Re: St. Lucie Plant Unit 2  
Docket No. 50-389  
Renewed Facility Operating License No. NPF-16

Response to NRC Reactor Systems Branch and Nuclear Performance Branch  
Request for Additional Information Regarding Extended Power Uprate License  
Amendment Request.

**Response to Reactor Systems Branch and Nuclear Performance Branch  
Request for Additional Information**

**Figure SRXB-54-1  
Total SI Flow Using One HPSI Pump**

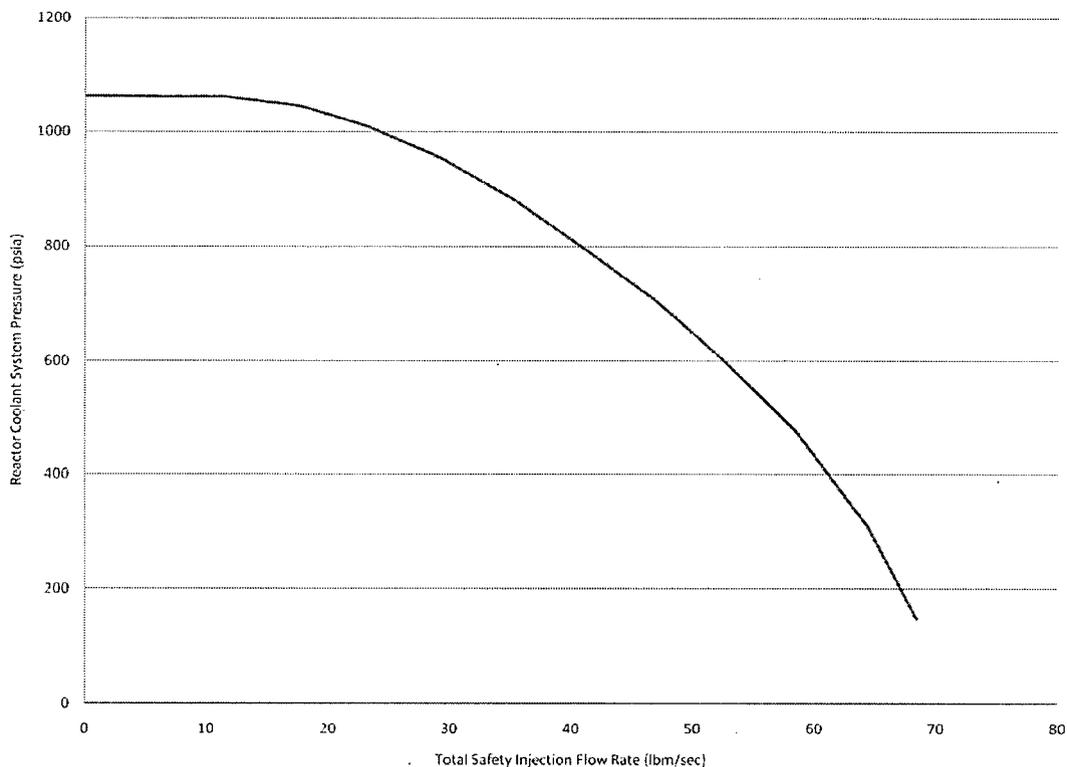
Figure 2.8.5.1.2-18 shows the safety injection (SI) flow curve used in the post-trip steam line break (SLB) analysis for EPU application. This curve appears different from the SI flow curve in UFSAR Figure 15.1.6-3, which is used in the analysis of record (AOR) for the post-trip SLB case. For example, Figure 2.8.5.1.2-18 shows that at the RCS pressure of 200 psia, the SI flow rate is 16.5 lbm/sec versus 70 lbm/sec shown in UFSAR Figure 15.1.6.3.

Explain why different SI flow curves are used for the EPU and AOR analyses, and verify that the SI flow is Figure 2.8.5.1.2-18 represents the flow characteristics of the SI pump for EPU operation.

The safety injection (SI) flow curve given in the Updated Final Safety Analysis Report (UFSAR) Figure 15.1.6.3, is the total SI flow (summation of all four cold legs using one high pressure safety injection (HPSI) pump). The SI flow curve given in the EPU LAR Attachment 5, Figure 2.8.5.1.2-18 is the SI flow for one cold leg using one HPSI pump. Figure SRXB-54-1 below is Figure 2.8.5.1.2-18 converted to total SI flow using one HPSI pump. For example, at 200 psia the minimum SI flow is ~16.5 lbm/sec per cold leg, therefore the total SI flow is 67 lbm/sec ( $\sim 16.5 \text{ lbm/sec} * 4$ ). Thus, the SI flow curve used for the EPU post-trip steam line break analysis has a slightly lower total SI flow than the analysis of record SI flow curve. This is conservative as it results in less boron injection after SI actuation.

**Figure SRXB-57-1**  
**Post-Trip SLB Cold Leg Temperature vs. Time**

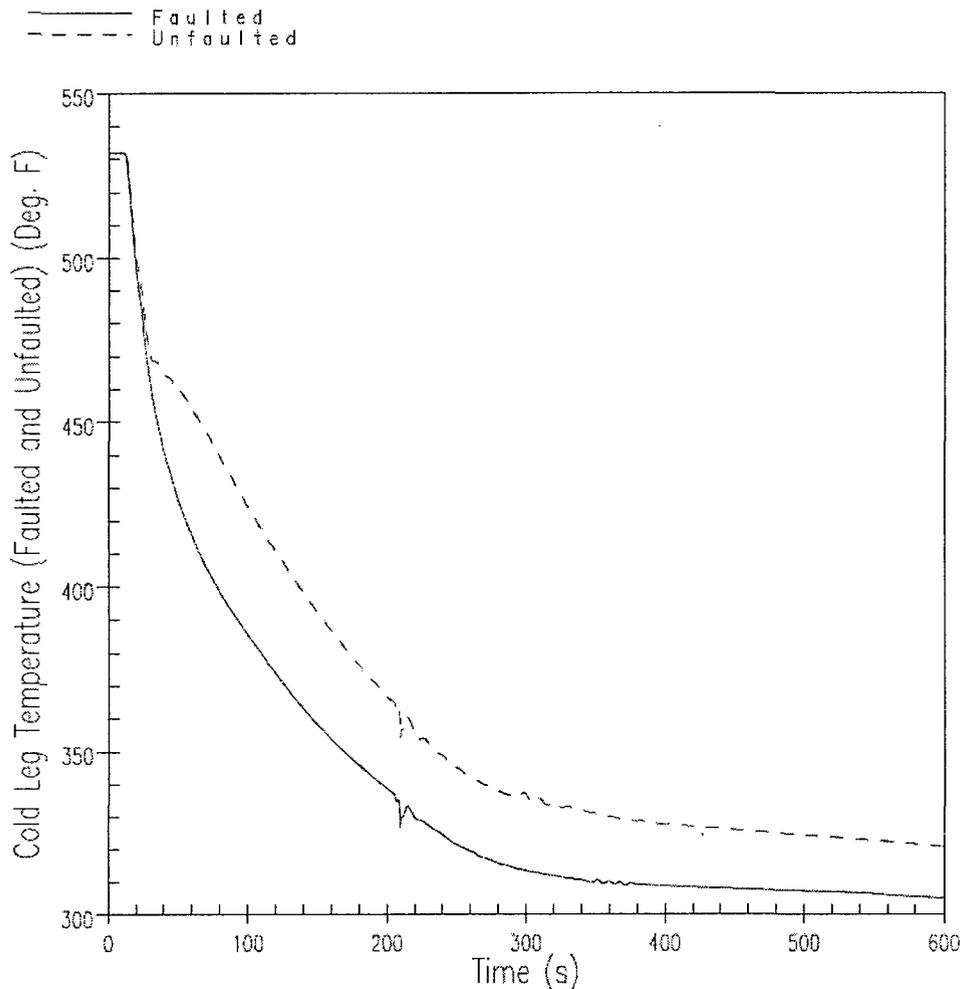
Figure 2.8.5.1.2-23 shows that the cold leg temperature (CLT) decreases rapidly after the SLB initiation. For the affected SG, at about 25 seconds the CLT suddenly increases until 30 seconds, following with a decrease of 8°F. From 38 to 41 seconds, the CLT increases by about 2°F, following with a continued decrease until 93 seconds when the pressurizer is refilled with water. After the pressurizer is refilled, the CLT turns to increase until 150 seconds when the computer runs ends

Explain thermal-hydraulic phenomena for the identified CLT increases during the above period of 0 to 150 seconds in response to applicable system actuations or operator actions.

The increase in cold leg temperature from about 25 to 30 seconds and then again from about 38 to 41 seconds in EPU LAR Attachment 5, Figure 2.8.5.1.2-23 is caused by a decrease in heat transfer from the primary to the secondary side. About ten seconds into the steam line break (20 seconds into the figure), the rapid depressurization of the steam generator (SG) causes the liquid (SLB) in the lower downcomer of the SG to flash to steam, forming a vapor bubble in the lower downcomer and lower bundle regions. Due to the high resistance of the evaporator region at this time, the vapor bubble is unable to move from the lower bundle and begins to degrade the heat transfer for that region of the SG U-tubes. The degradation in heat transfer reduces the amount of energy removed from the primary side, retarding the cooldown of the primary side. This resulted in an appearance of the hot leg temperature in the cold leg. Hence, the initial cold leg temperature increase seen at about 25 seconds in Figure 2.8.5.1.2-23.

Along with the temporary loss of heat transfer in that area of the bundle, the depressurization of the SG continues. Eventually, heat transfer from the primary to secondary sides at the lower bundle portion of the SG U-tubes is restored. At which time, cooldown of the reactor coolant system (RCS) recommences and the cold leg temperature begins to decrease again. This is seen at 30 seconds in Figure 2.8.5.1.2-23.

The second increase and decrease 38 to 41 seconds into Figure 2.8.5.1.2-23 is the re-appearance (with one RCS loop time delay) of the first temperature excursion seen between 25 to 30 seconds in the Figure. Between these times, the warmer water is passing through the cold leg once again, but at a cooler condition since heat transfer had been restored. After an additional cycle time, the block of warmer water had been sufficiently mixed and cooled down to see no further increase in the cold leg temperature until 93 seconds.

A sensitivity study was performed to eliminate the vapor lock condition thereby improving the primary to secondary heat transfer and increase the RCS cooldown. The study determined that when there is no vapor lock, the event is extended beyond that noted in the analysis of record (AOR) and the maximum heat flux is 6.0% (the EPU analysis maximum heat flux was 5.6%). The EPU analysis calculated a minimum departure from nucleate boiling ratio (DNBR) of 4.307 with a limit of 1.30 whereas the sensitivity study calculated a minimum DNBR of 3.611. The other major assumptions remained the same between the AOR, EPU and sensitivity study. Those assumptions are that feedwater flow matches steam flow and the feedwater enthalpy is equal to that of the AFW so that the primary system cooldown is maximized. The cold leg temperature vs. time plot from the study is presented in Figure SRXB-57-1.

**Figure SRXB-61-1**  
**Loss of Normal Feedwater with Offsite Power Available**  
**Hot and Cold Leg Temperature vs. Time**

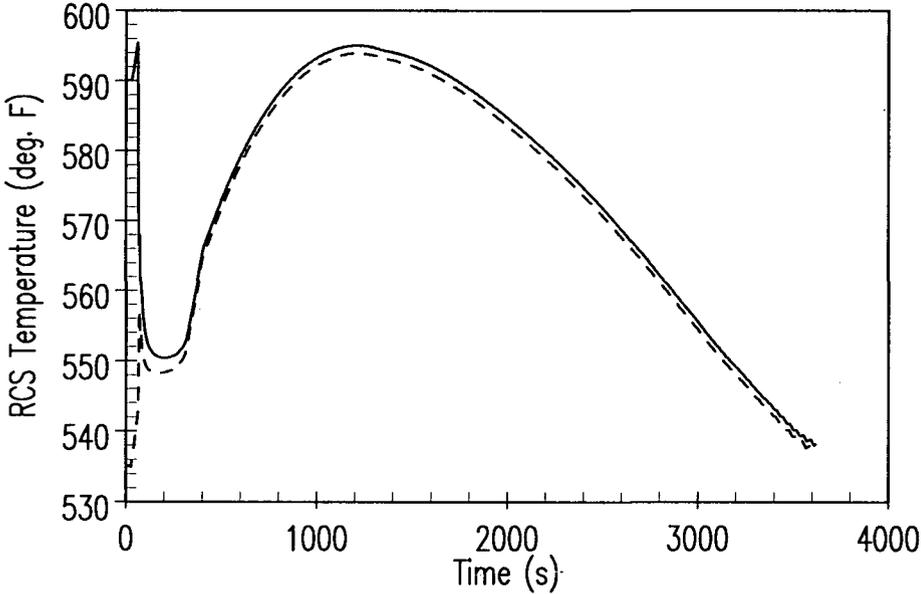
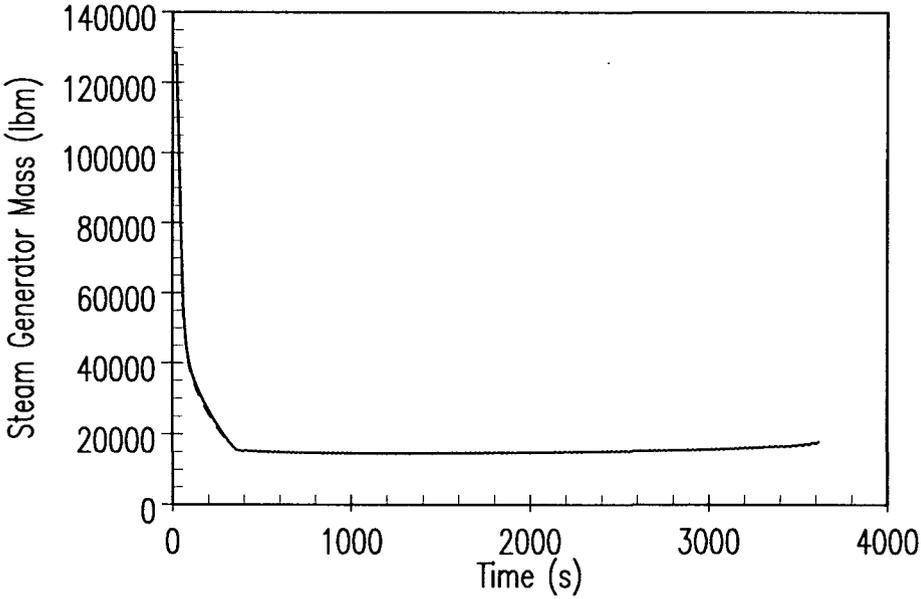
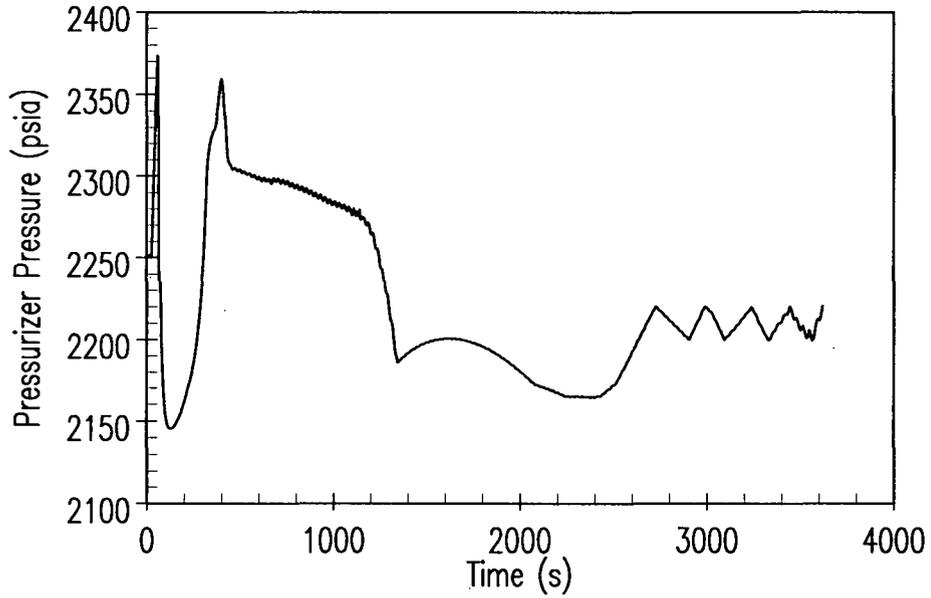
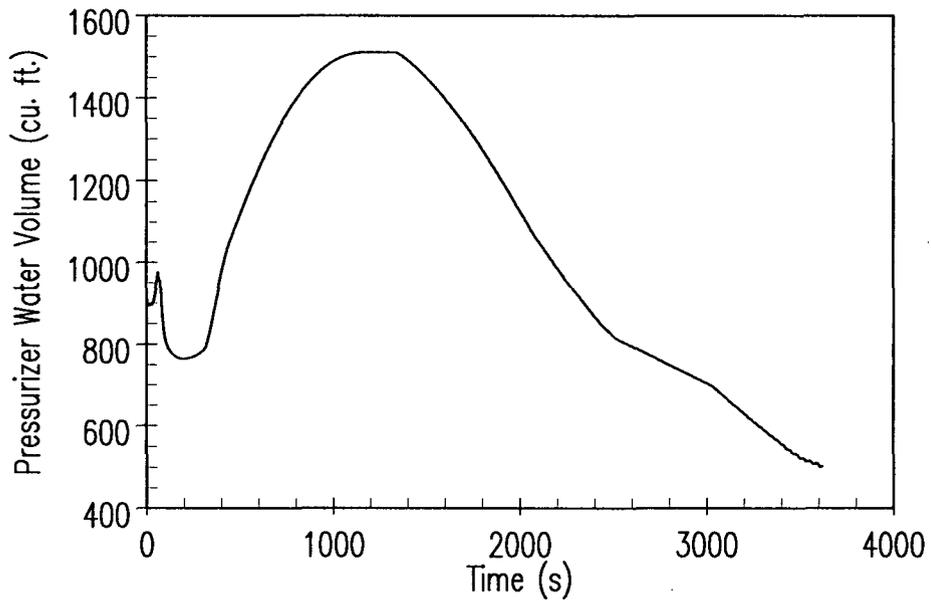
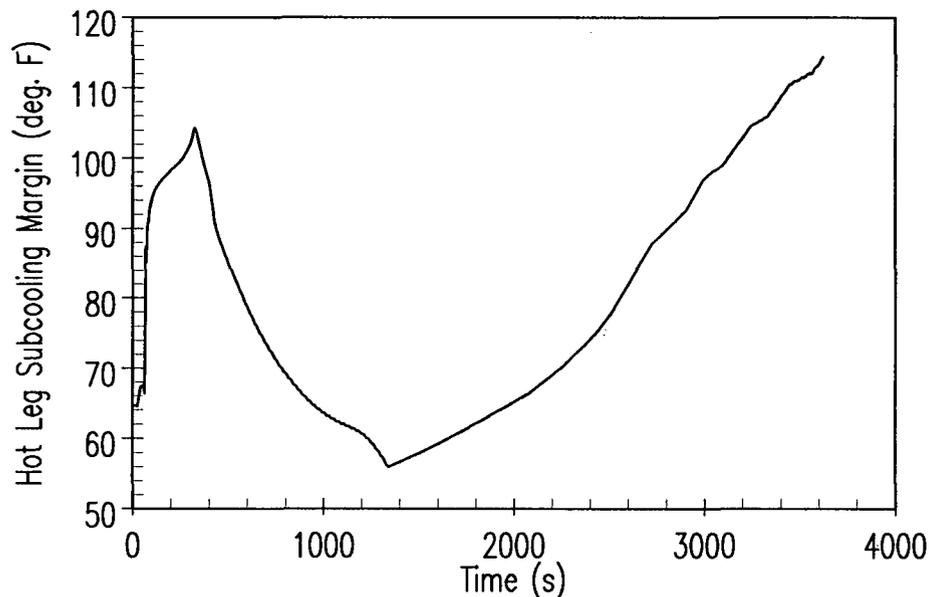
Page 2.8.5.2.2-3 indicates that with respect to long-term cooling (LTC) for the event initiating from a loss of non-emergency AC power to the station auxiliaries (LOAC), the ability of the auxiliary feedwater (AFW) system to remove decay following reactor trip is demonstrated by the analysis in UFSAR Chapter 10. Page 2.8.5.2.2-5 also states LTC analysis for the LOAC is presented in LR Section 2.5.4.5.

Item 1 above is satisfied by assuring that the steam generators (SGs) do not lose heat transfer capability during the event and are able to reduce the RCS temperature. As such, as long as inventory remains in the SGs, the AFW system is proven to provide sufficient capability for decay heat removal. Item 2 above is satisfied by demonstrating that subcooling margin is maintained throughout the entire event and inventory remains in the SGs. Item 3 above is satisfied by assuring the maximum pressurizer pressure remains below the PSV opening setpoint.

The LNF analysis performed in accordance with UFSAR Section 10.4.9A shows that more than 10% of the initial SG mass exists in either SG at the end of the transient. Sufficient SG heat transfer capability is proven through the reduction in RCS temperature shown in Figure SRXB-61-1. The pressurizer water volume remains below 1519 ft<sup>3</sup>, and as such, the pressurizer does not reach a water solid condition. Pressurizer pressure, despite rising initially, remains below the PSV setpoint and the PSVs do not open during the event. Subcooling margin is maintained throughout the entire event.

**Figure 2.8.5.6.1-1**  
**RCS Depressurization**  
**Nuclear Power vs. Time**

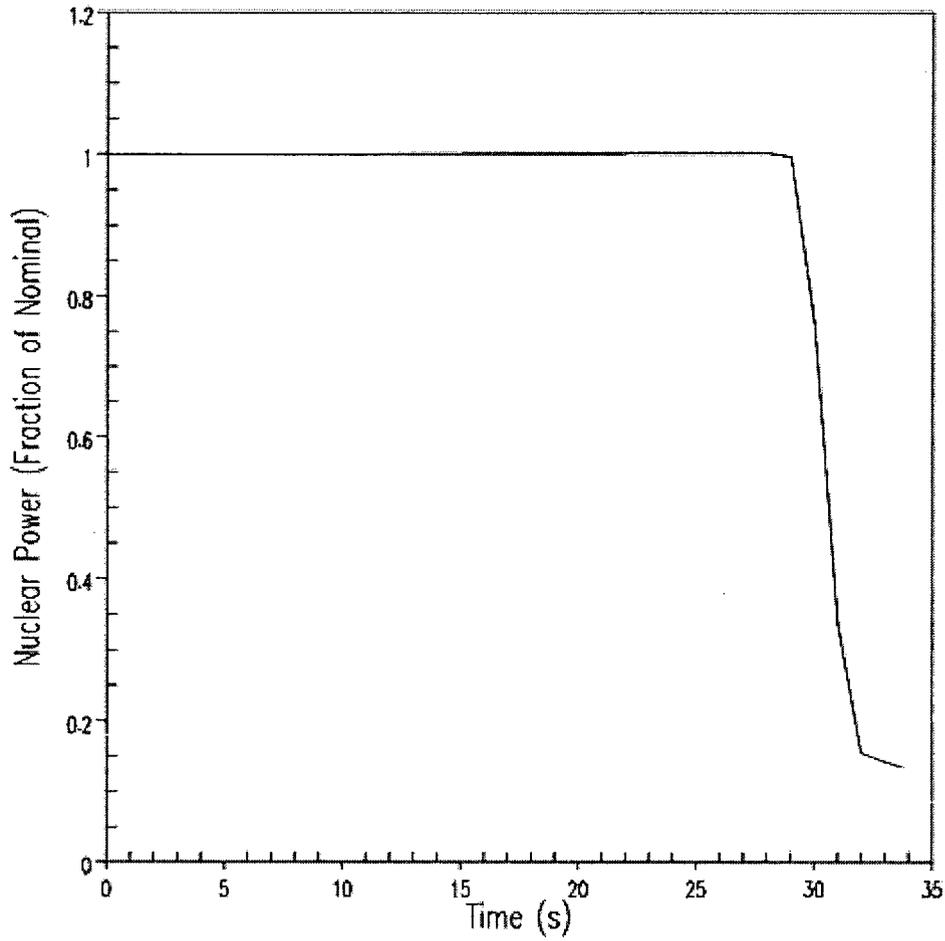
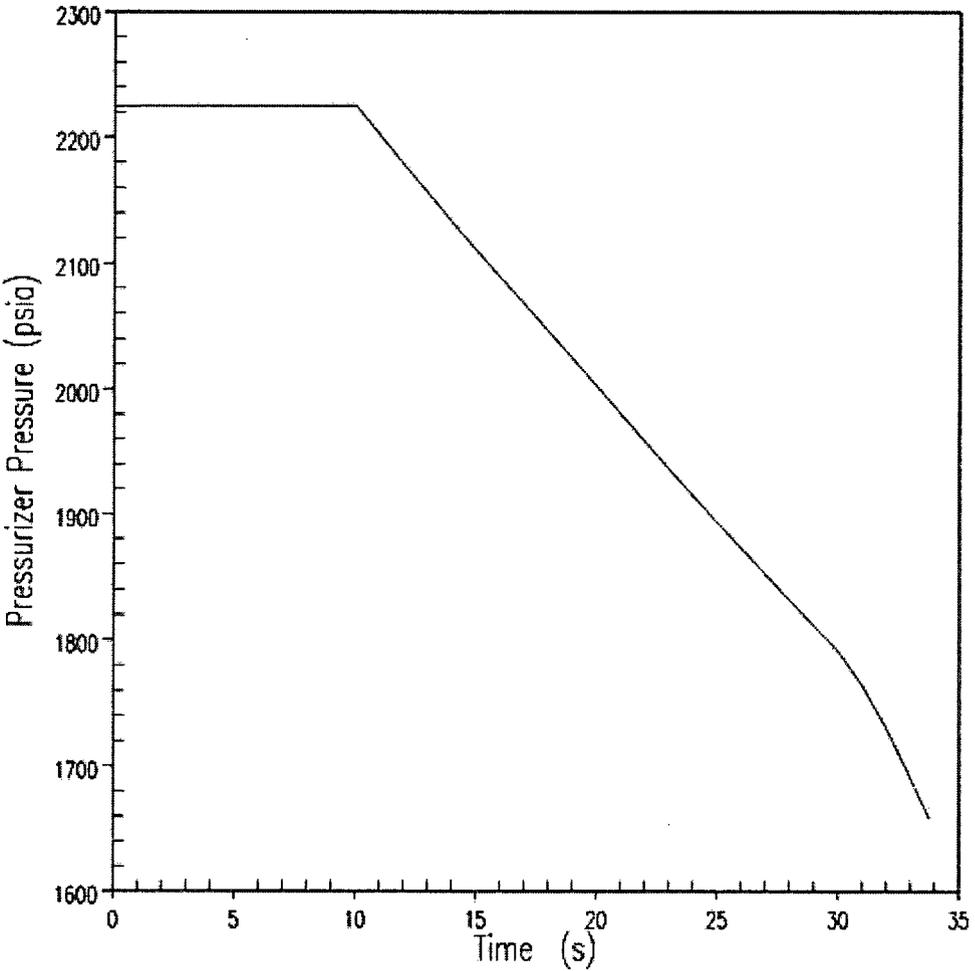
**The titles for Figure 2.8.5.6.1-1 and Figure 2.8.5.6.1-2 are nuclear power and pressurizer pressure vs. time, respectively, while the respective plots show the pressurizer pressure and vessel average temperature vs. time.**

**Clarify the inconsistencies and provide correct figures for review.**

In EPU LAR Attachment 5, Figure 2.8.5.6.1-1 was inadvertently omitted from the document, but the correct title of Nuclear Power vs. Time was maintained. Figure 2.8.5.6.1-2 Pressurizer Pressure vs. Time was replaced with Figure 2.8.5.6.1-3 Vessel Average Temperature vs. Time. However, the correct title of Pressurizer Pressure vs. Time was maintained. EPU LAR Figure 2.8.5.6.1-3 Vessel Average Temperature vs. Time was repeated as Figure 2.8.5.6.1-3, aligning the remaining Figures 2.8.5.6.1-3 through 2.8.5.6.1-5 with the correct title. Figure 2.8.5.6.1-1 and Figure 2.8.5.6.1-2 are provided below. Figures 2.8.5.6.1-3 through 2.8.5.6.1-5 of Section 2.8.5.6.1 remain as presented and are correct.
